Environmental Restoration Program

Second Five-Year Review Report

Operable Unit 6

SUBJECT: Final Second Five-Year Review Report, National Aeronautics and Space Administration, Armstrong Flight Research Center, Operable Unit 6, Edwards Air Force Base, CA

The areas in which the various RA components were targeted for implementation are shown on Figure 4-1.

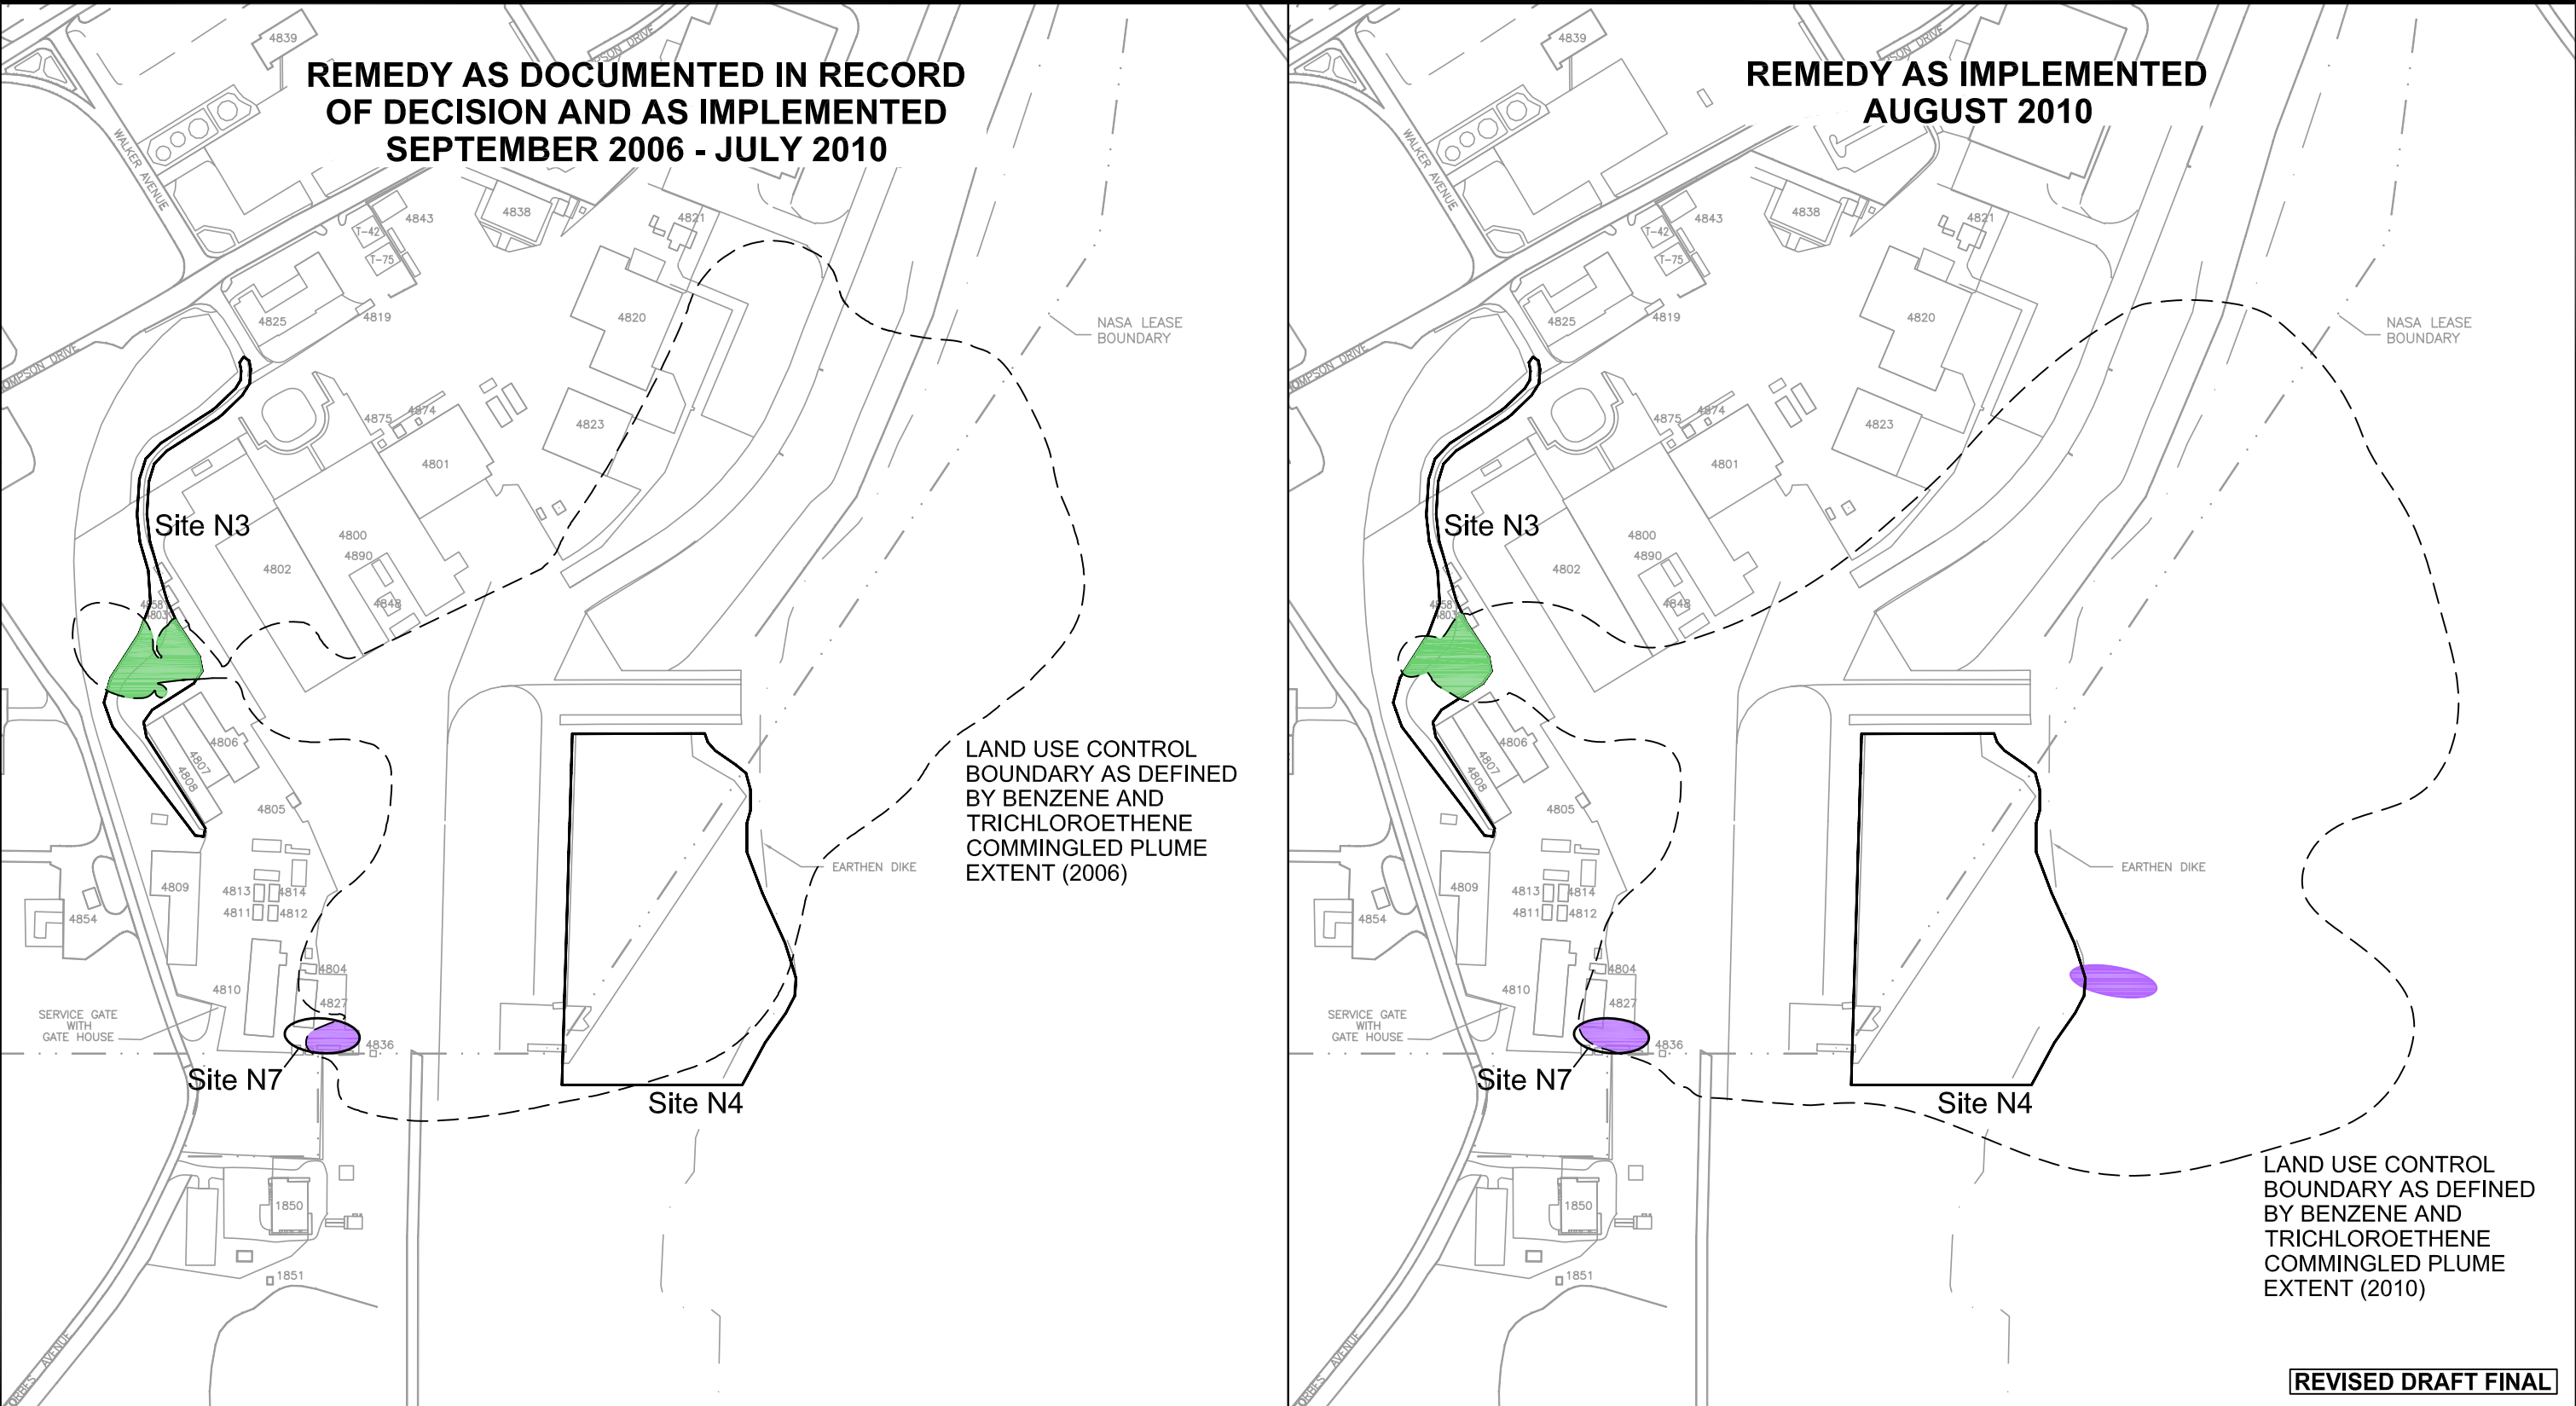
Initial General Comment 2: Page 6-7 indicates that performance monitoring results associated with the Phase II - Injection Event II (i.e., June-July 2010) were not available within this review period; however, Table 6-3 includes TCE Concentrations from several wells sampled during the June-July 2010 performance monitoring event. As such, it is unclear if the information presented in the Five-Year Review is up-to-date. For example, it is unclear if the land use control (LUC) boundary, presented in Figure 4-1 (Land Control Boundary), represents the 5- $\mu\text{g}/\text{L}$ isoconcentration contour from the June-July 2010 monitoring event. Please ensure that the final Five-Year Review includes information from reports that are submitted in late 2010/early 2011.

Initial Response General Comment 2: Phase II Injection Event II occurred in August 2010 not June-July 2010. Figure 4-1 (now Figure 4-2 due to document reorganization) includes the LUC boundary based on the June-July 2010 monitoring results. The following note has been added to the figure: “Land use control boundary based on 2010 contaminant concentrations”.

P:\60133976\WP\90\cad\Revised Draft Final\Figure 6-4 OU6 TCE 2010-trend.dwg - 17 Aug 2011

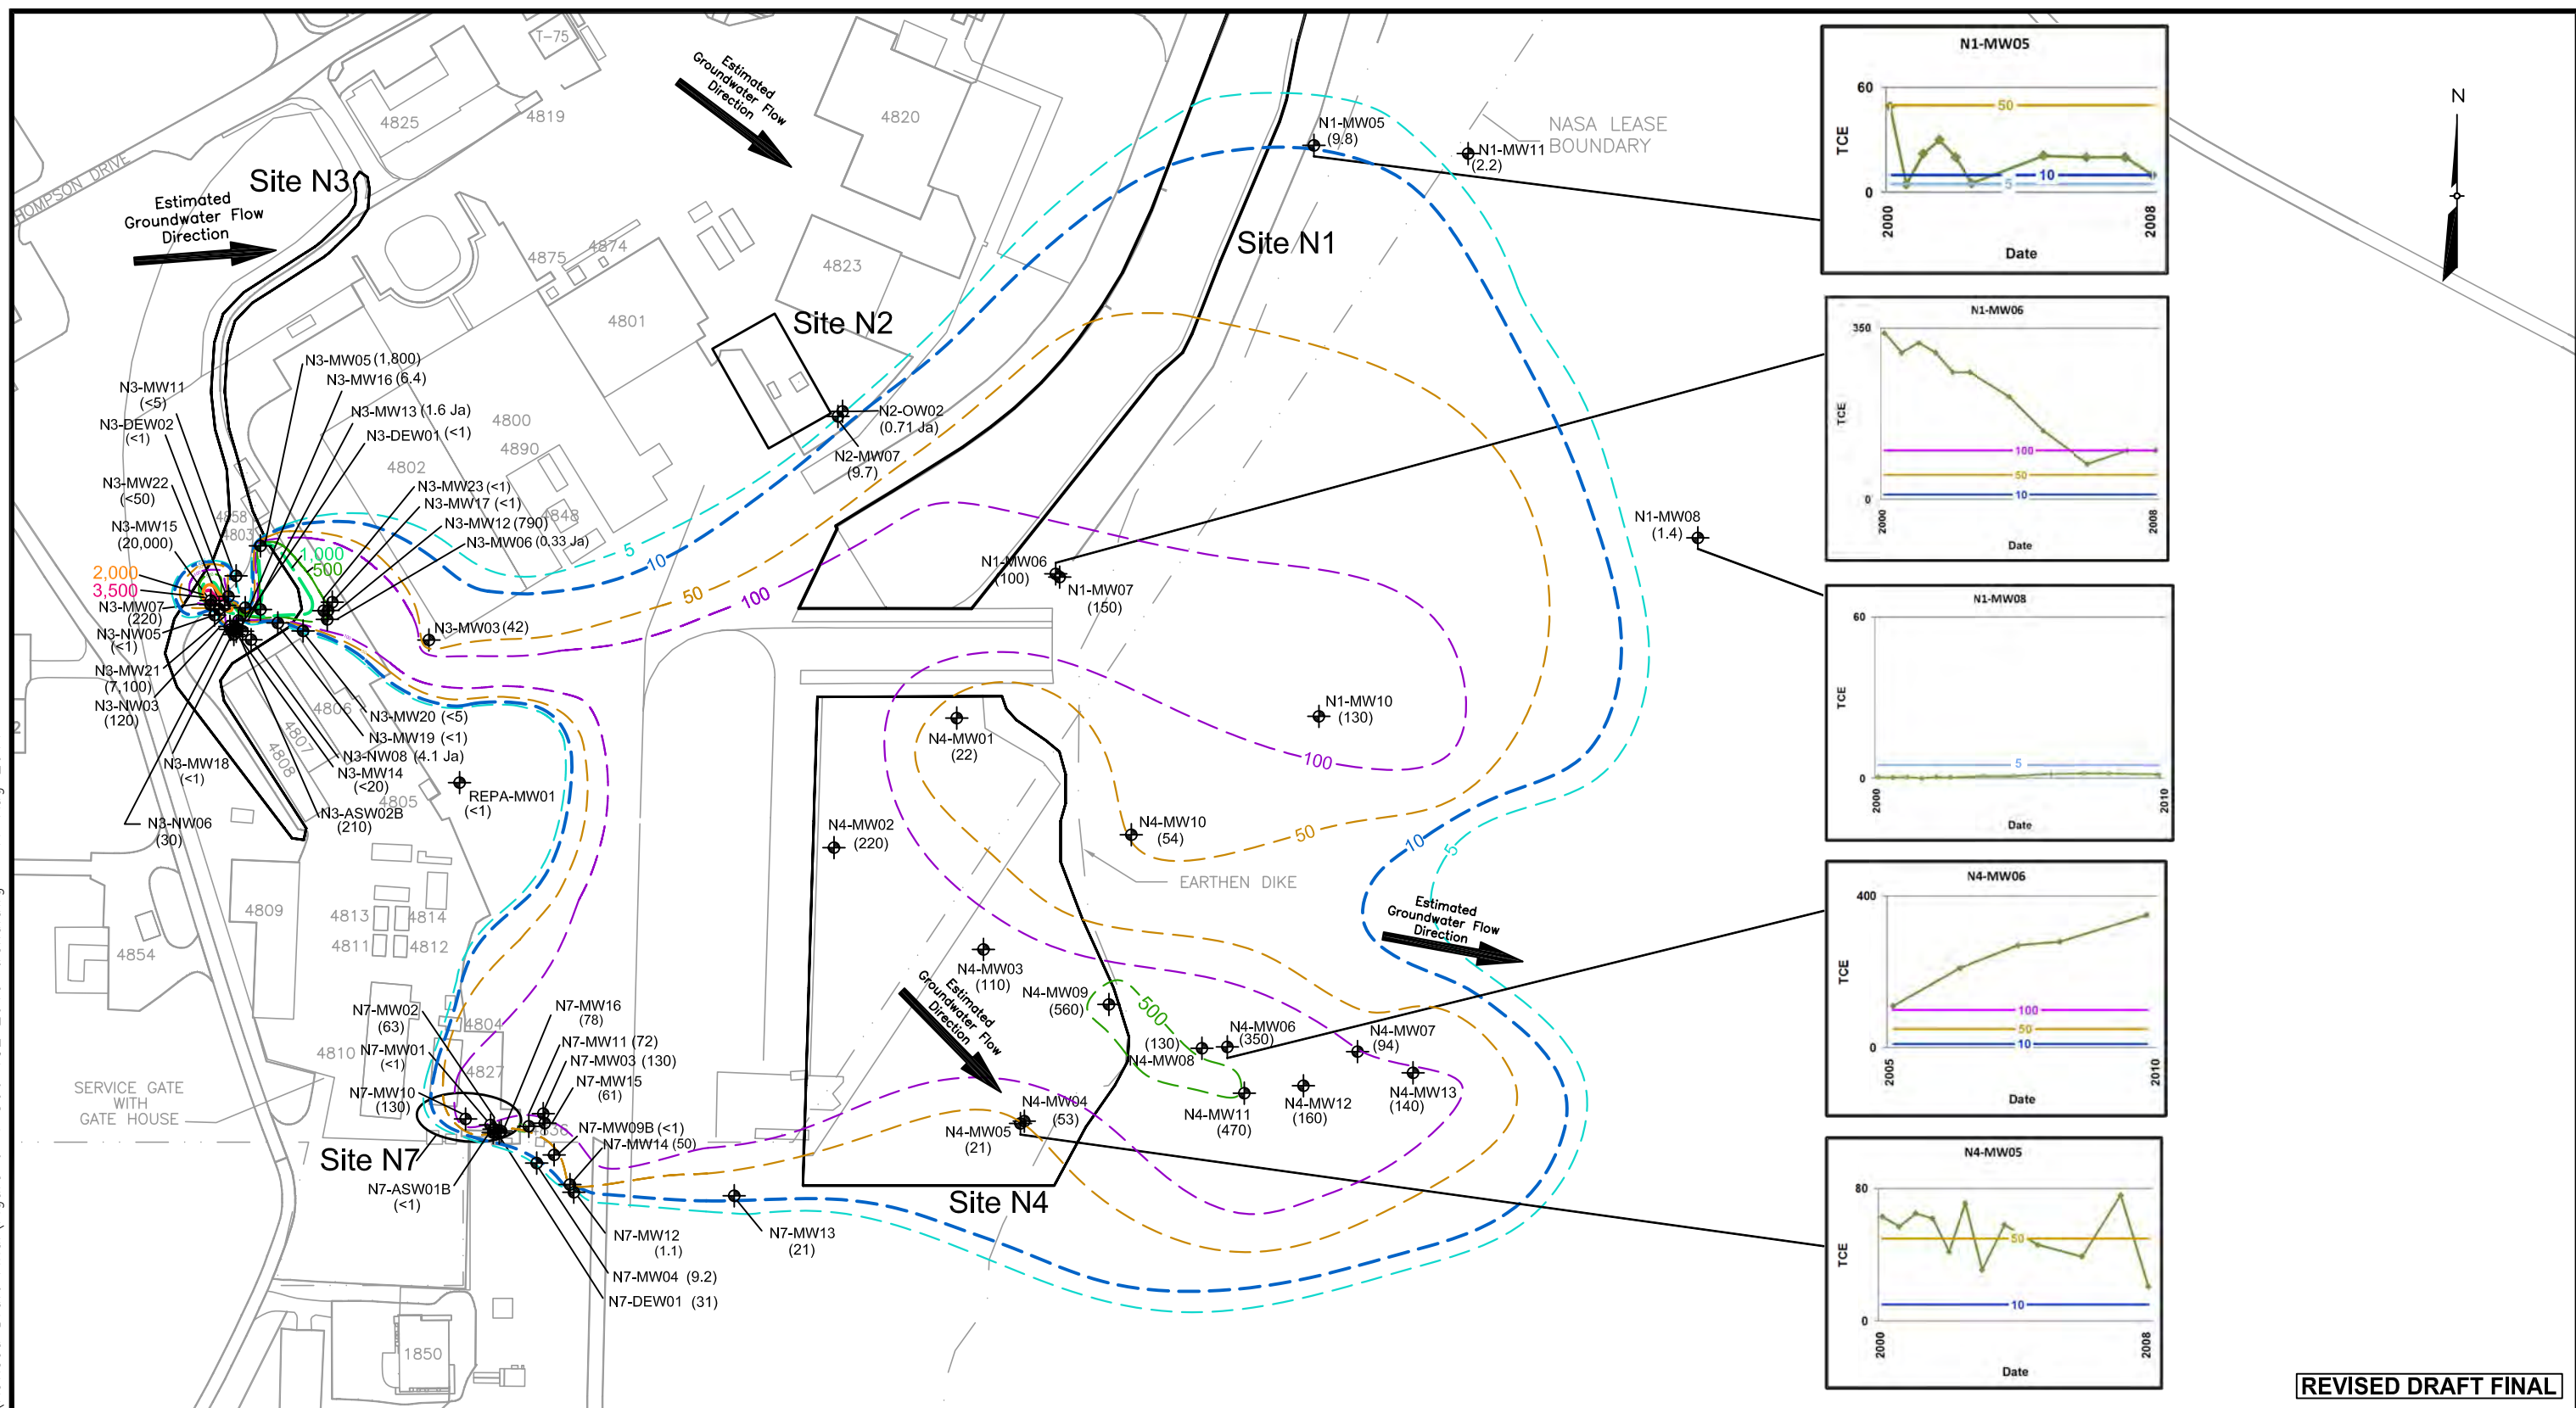
Initial General Comment 4: Based on Figures 2-1 (TCE Groundwater Concentration Contours - 2010) and 6-2 (Approximate Extent of TCE in Groundwater), it does not appear that the current extent of groundwater contamination at OU6 is sufficiently delineated. For example, no monitoring wells exist north of N3-MW03, N2-MW07, N1-MW05 or N1-MW11; west of N1-MW11, N1-MW08, N1-MW10, or N4-MW13; or south of N7-MW13, N4-MW05, N4-MW04, N4-MW11, N4-MW12, or N4-MW13. In addition, the Implementation of the Remedy subsection of Section XI (Overall Observations) of Appendix C (Site Inspection Report) indicates that groundwater sampling of newly installed wells along the plume's leading edge indicate that the plume is larger than predicted. While additional monitoring wells are proposed to delineate the leading edge of the groundwater plume, additional step-out monitoring wells may be necessary to address data gaps associated with the current extent of the plume. Sufficient wells should be installed to fully delineate the extent of the plume and monitor plume expansion or migration. Please revise the Five-Year Review to recommend additional monitoring wells to determine the current extent of the groundwater plume so that data from existing monitoring wells and proposed leading edge monitoring wells can be used to determine how fast the groundwater plume is expanding.

Since the entire comment does not specifically apply to the content of the *Addendum to First FYRR*, if applicable, text similar to the following may be included in the Second FYRR to further address the comment: Well locations and associated 2003 and 2010 TCE concentrations are shown on Figures 3-4 and 3-5, respectively. Figure 6-3 presents the extent of the TCE plume delineated in 2003 (at the time of remedy development in the FS [Earth Tech 2004]), in 2004 as presented in the ROD (USAF 2006), and in 2010 (latest data available during the reporting period [November 2010 through August 2011]). The area in blue indicates the change in estimated plume configuration along the east/southeastern leading edge as a result of TCE concentrations detected in newly installed wells N1-MW10, N4-MW07, N4-MW11, N4-MW12, and N4-MW13. As indicated in Section 1.2, though the Plume Characterization Key Action Item is not expected to be complete until the Second FYRR in September 2016, this document includes a discussion of the plume delineation based on the most-recent data available. Figures showing groundwater TCE and benzene plume estimates based on data collected since the five-year review reporting period, including preliminary data, are included in Appendix E. Figure E-1 in Appendix E is provided as an update to Figure 6-3 to present the difference in plume

estimates between 2010 and 2012. Trend graphs for wells with an adequate number of data points during the review period are included on Figure 6-4, and indicated that the leading edge of the plume is exhibiting instability as indicated by increasing TCE concentrations at monitoring wells including N4-MW06. TCE concentrations in samples collected from monitoring well N4-MW06 have consistently increased between 2005 and 2010. Additionally, analytical results from the 2010 monitoring event indicated that an area of relatively high TCE concentrations, ranging from 21 to 560 $\mu\text{g/L}$ (Figure 3-5), exists in the Site N4 area. To address this high concentration area and apparent plume instability in the vicinity of monitoring well N4-MW06, Site N4 area injection wells (N4-MW07, N4-MW08, and N4-MW09) were included in the Phase II Injection Event II. Though performance monitoring results associated with the Phase II Injection Event II were not available within the reporting period (November 2010 through August 2011), continued sodium permanganate solution injections at the Site N4 area will likely be required.
